**NOTICE OF ADDENDUM
ADDENDUM NO. 2
City of Madison, Engineering Department**

**CONTRACT NO. 9359
Country Grove Park Shelter**

This addendum is issued to modify, explain or correct the original Drawings, Specifications, or Contract Documents marked as **Country Grove Park Shelter, City of Madison, Contract #9359, as issued on February 1, 2024** and is hereby made a part of the contract documents.

SHEET NUMBER:
C1.4

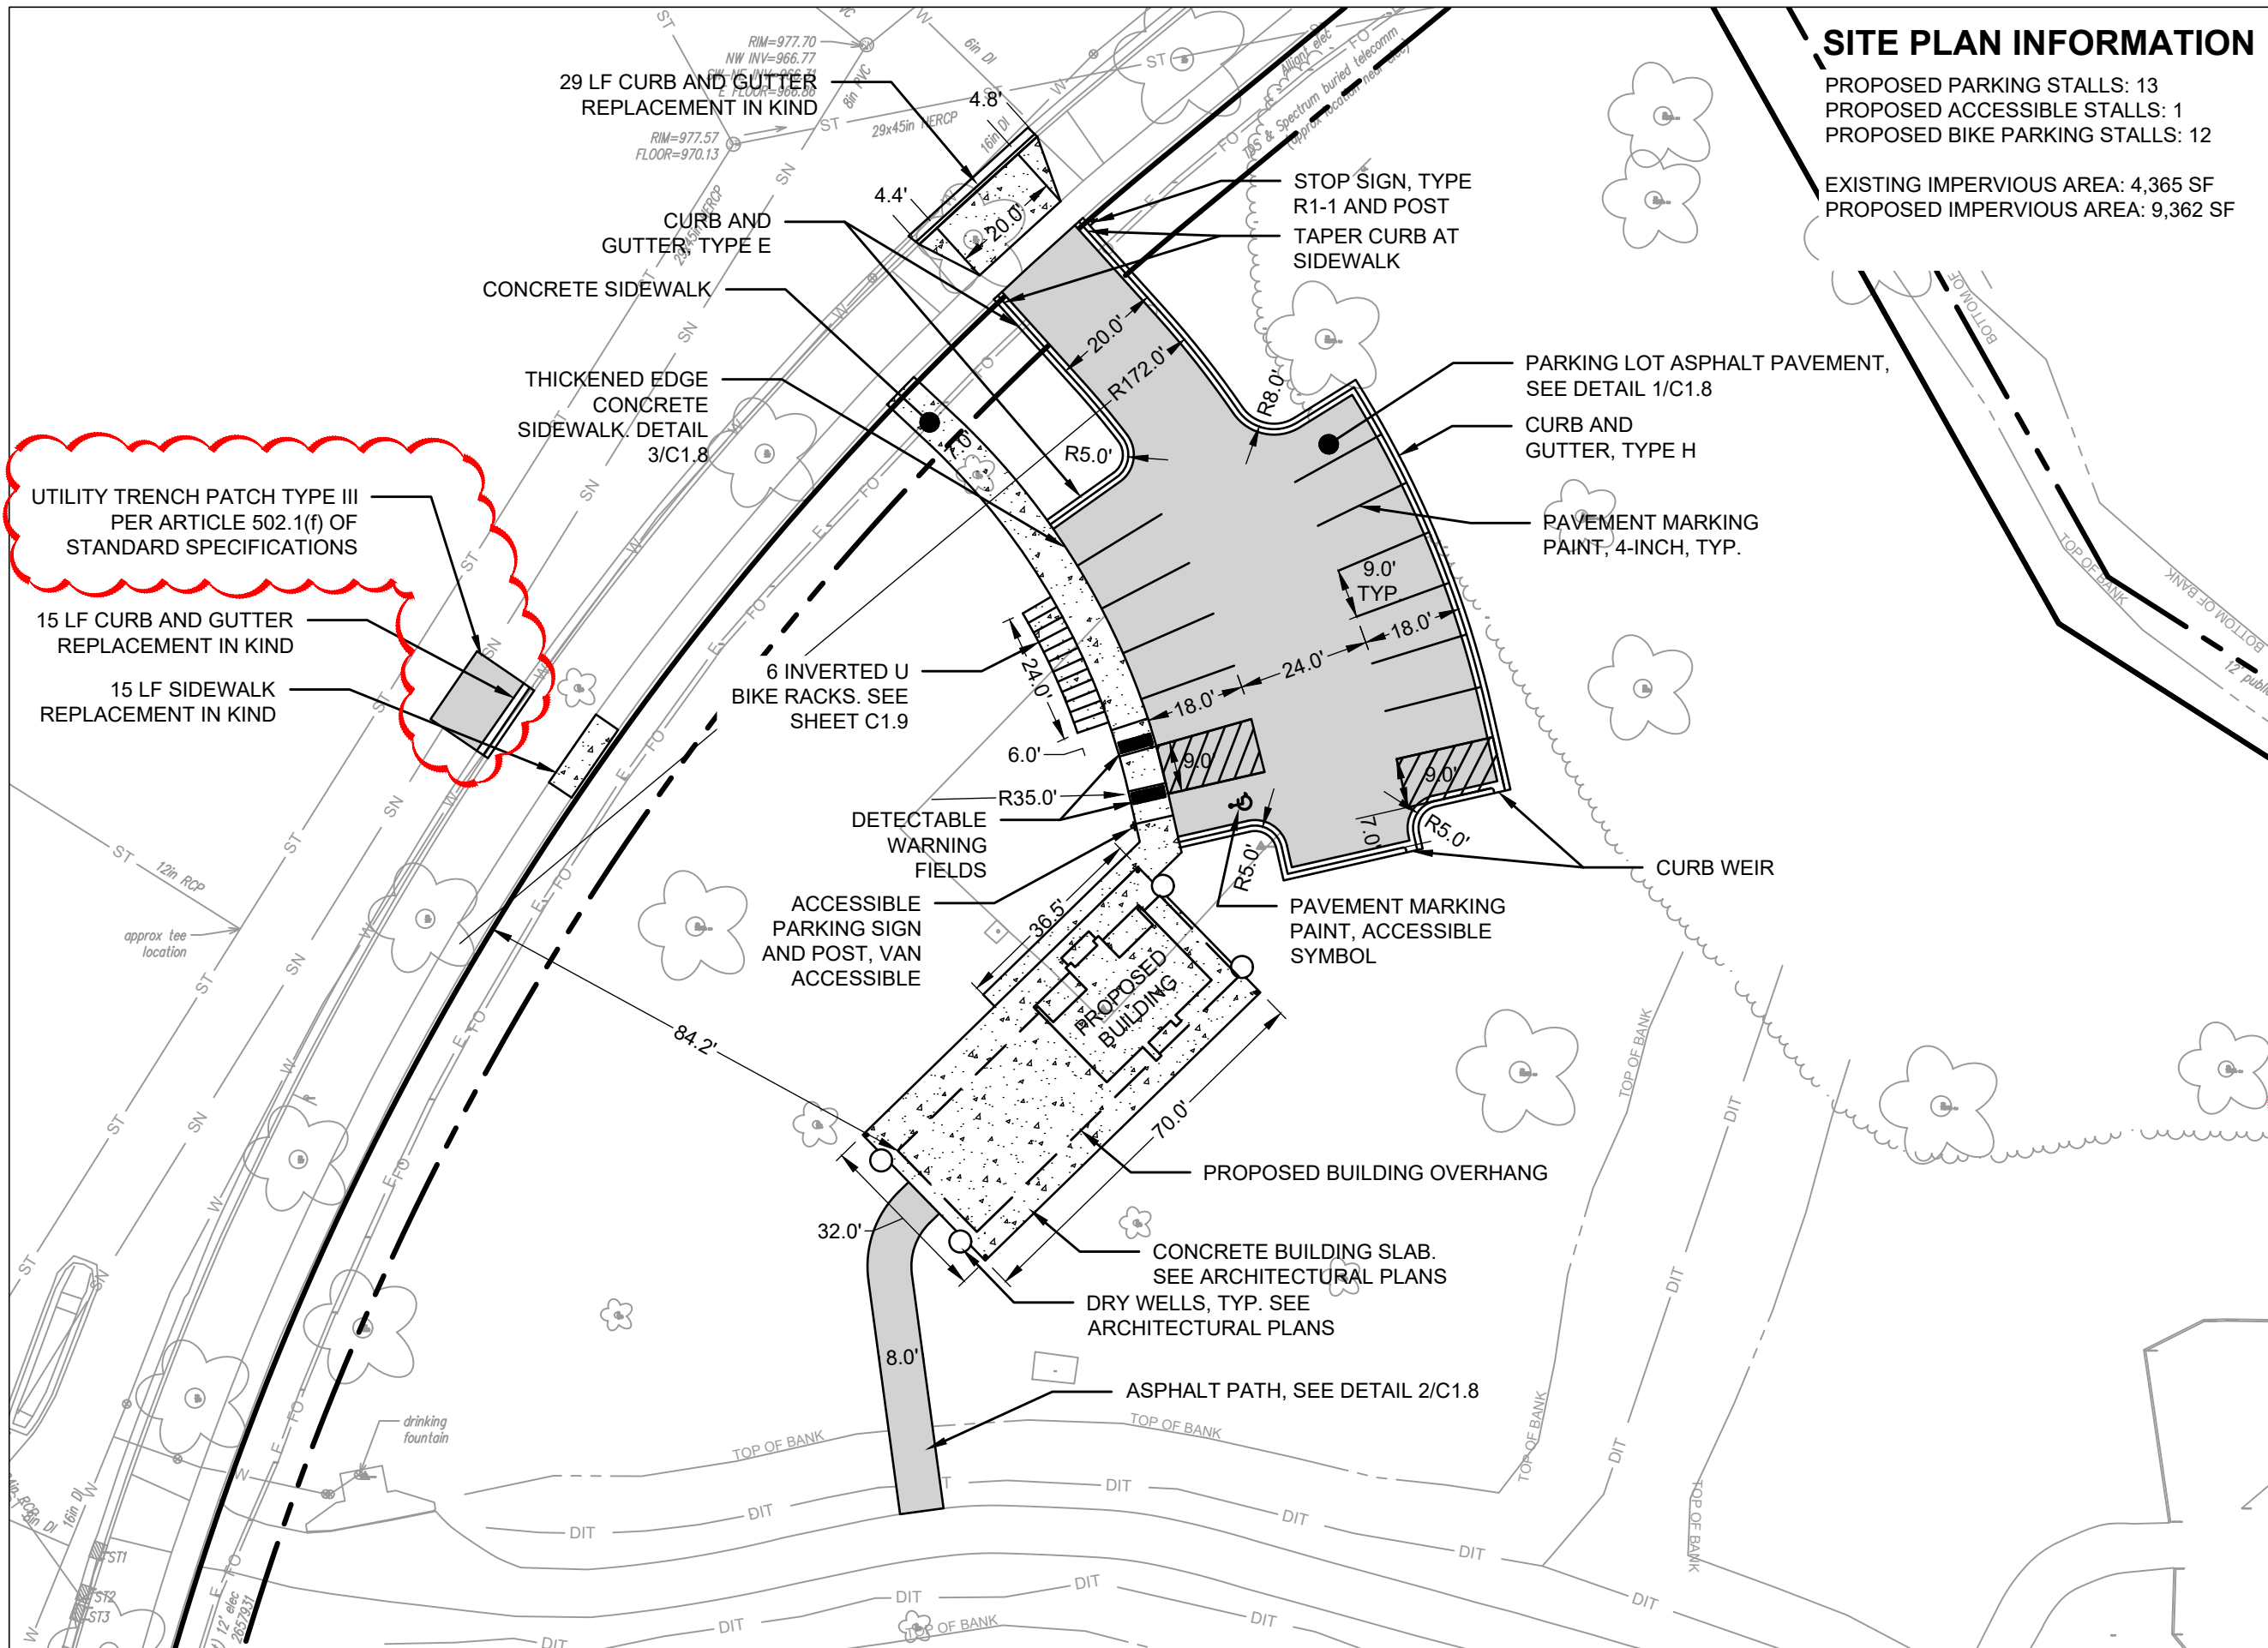
- i. **Drawing C1.3:** Replace with attached sheet.
 - Plan updated to reflect Utility Trench Patch Type III requirements in East Pass. Requirements can be found in Article 502.1(f) of the Standard Specifications. Pavement rating of East Pass is 6.
- ii. **Drawing C1.4:** Replace with attached sheet.
 - Plan updated to reflect Utility Trench Patch Type III requirements in East Pass. Requirements can be found in Article 502.1(f) of the Standard Specifications. Pavement rating of East Pass is 6.

A1: The street patch should be a Utility Trench Patch Type III In accordance with Article 502.1(f) of the Standard Specifications. The 50' patch width shown on the plans is actually not necessary since the pavement rating of the street is not over 6. Reference attached drawing C1.3 & C1.4

2 ROOF FRAMING PLAN
1/4" = 1'-0"

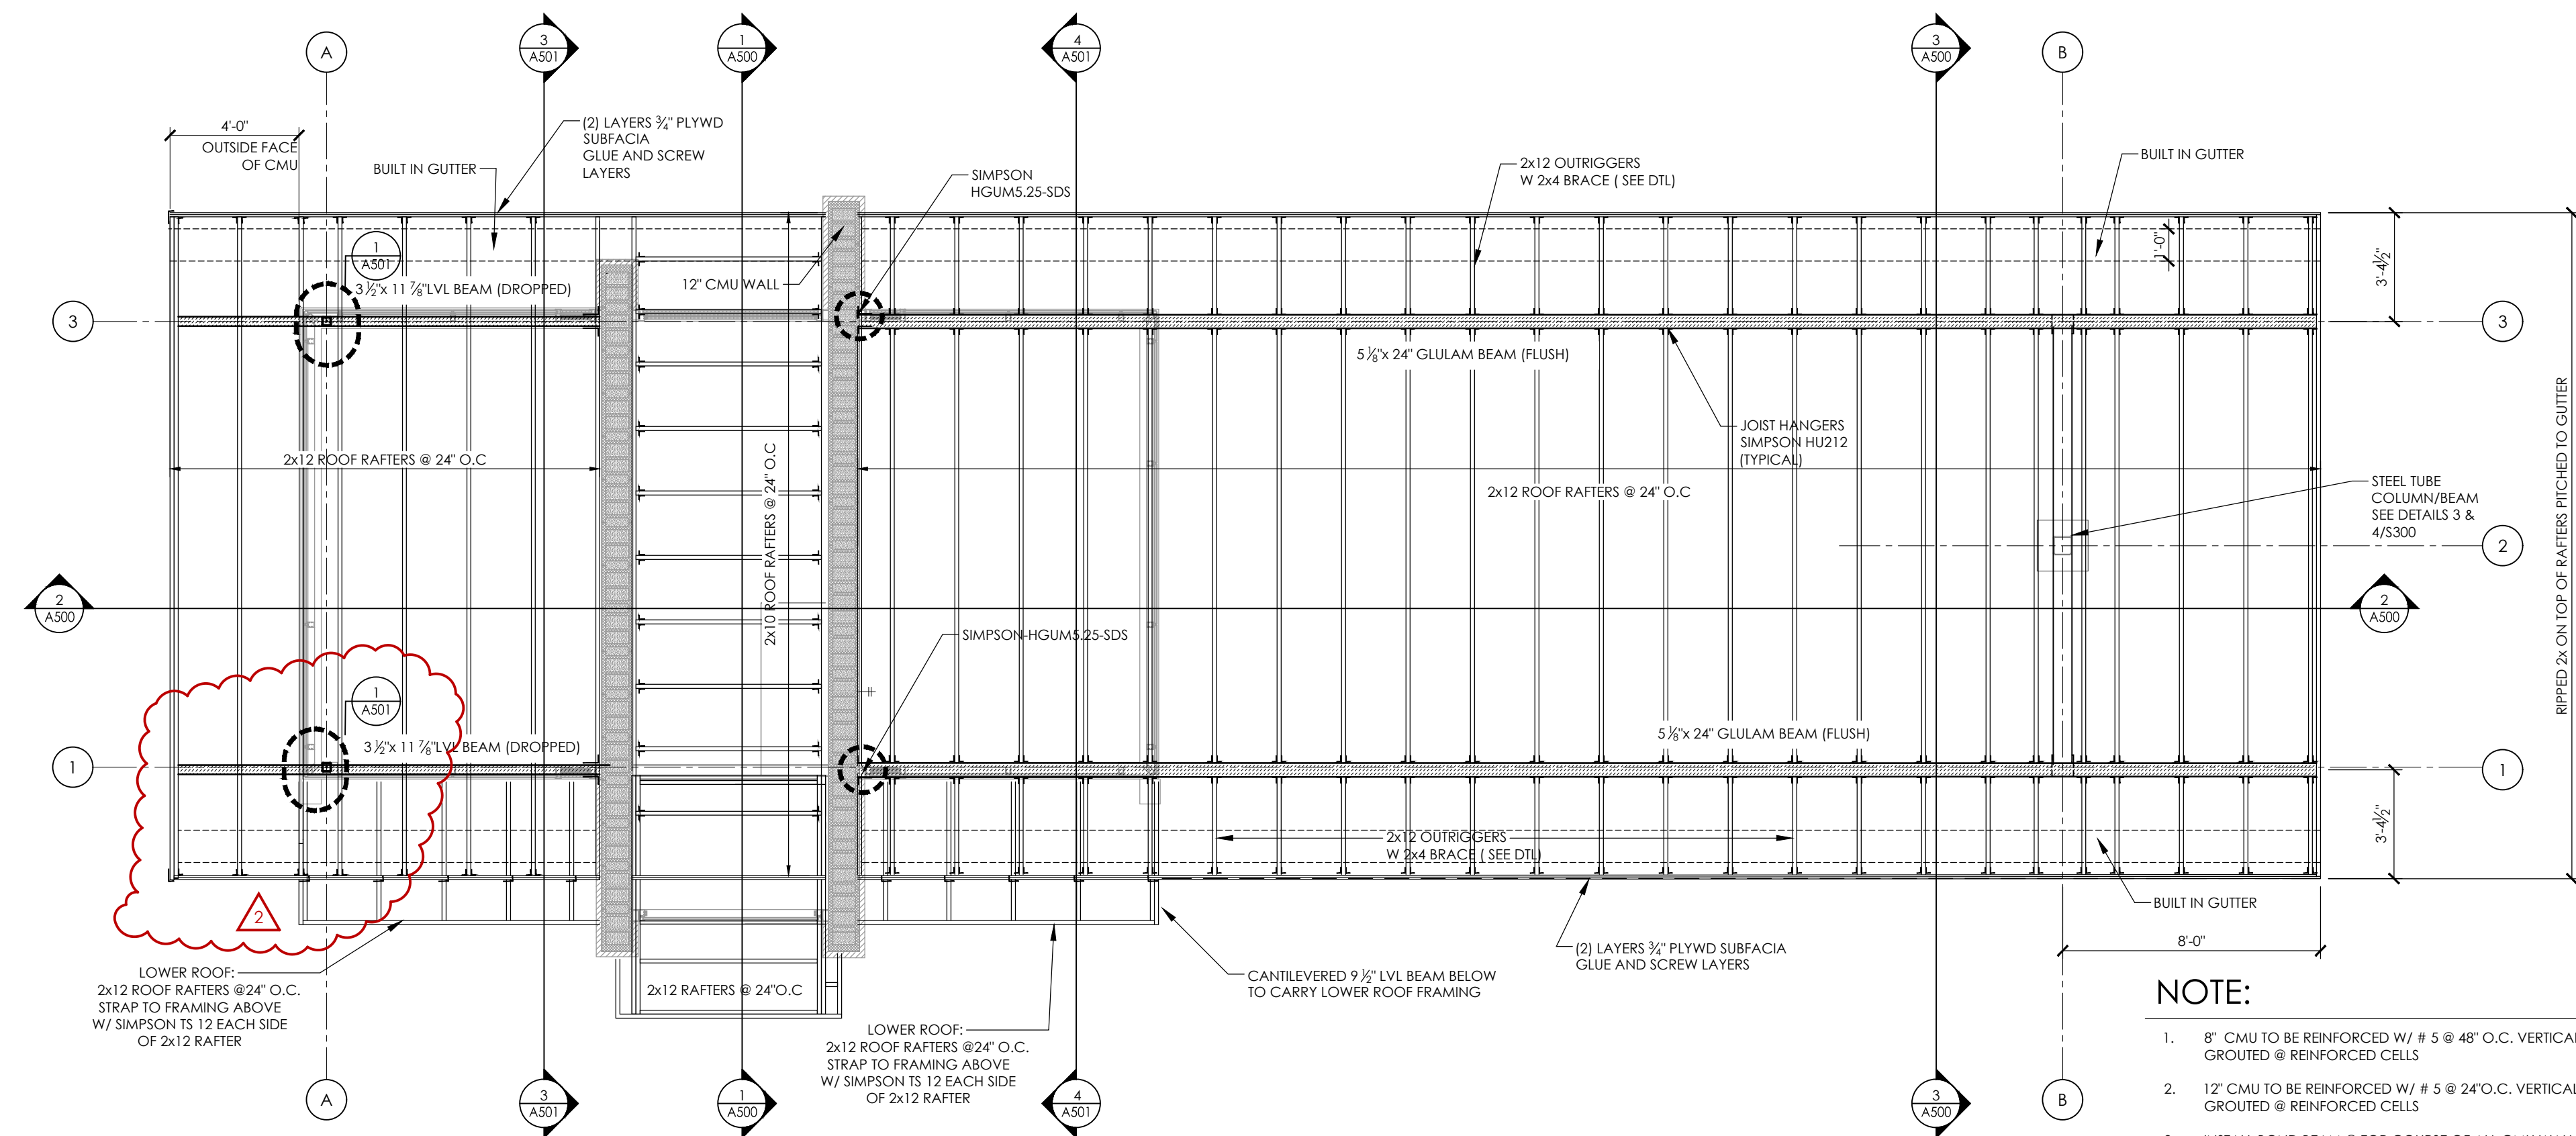
- i. **Drawing S100:** Replace with attached sheet.
 - Revise foundation plan 1/S100. Partition for foundation wall changes from 8" to 10"
 - Move note for clarity 1/S100
 - Revise column location & updated window framing background 2/S100
- ii. **Drawing A100:** Replace with attached sheet.
 - Revise 1/A100 adjusted column A location & changed partition of wood wall to CMU.
- iii. **Drawing A300:** Replace with attached sheet.
 - Revise elevation 1/A300 changed partition of wood wall to CMU
- iv. **Drawing A500:** Replace with attached sheet.
 - Revise 1, & 2/A500 Changed window frame section
 - Revise 2/A500 adjusted column location
- v. **Drawing A501:** Replace with attached sheet.
 - Revise 1, 3 & 4/A501 Changed window frame section
